CAISO Comments on: AB 1632 Assessment of California's Operating Nuclear Plants - Draft Report

Bob Emmert - CAISO
Sr. Loads & Resources Engineer

CEC Joint Committee Workshop on the AB 1632
Nuclear Power Plant Assessment

September 25, 2008

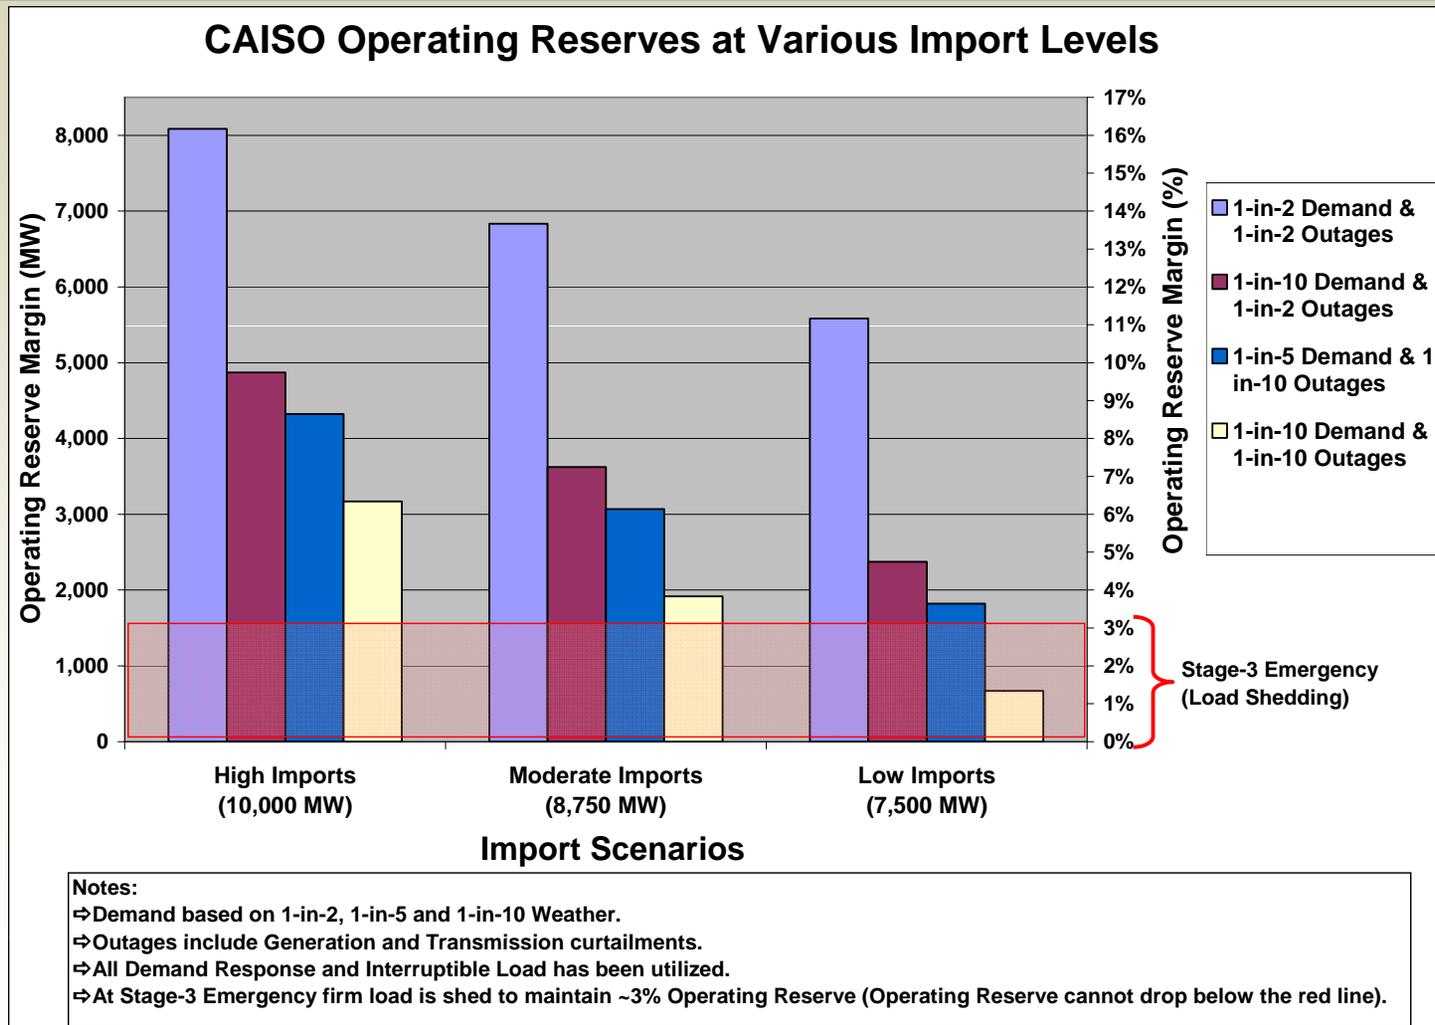
- “Table 6 shows that under normal conditions and given current loads and resources, there is a 23.9 percent planning reserve margin, which is well above the CPUC’s required resource adequacy margin of 15 percent to 17 percent. (p. 202)

- Table 6 is based on a “planning perspective” based on various planning assumptions, not normal conditions.
- The 19.9% - 23.9% planning reserve margins represented were projections of what is now a historical timeframe and it is not appropriate to use these planning reserve margins to make conclusions about potential future events.
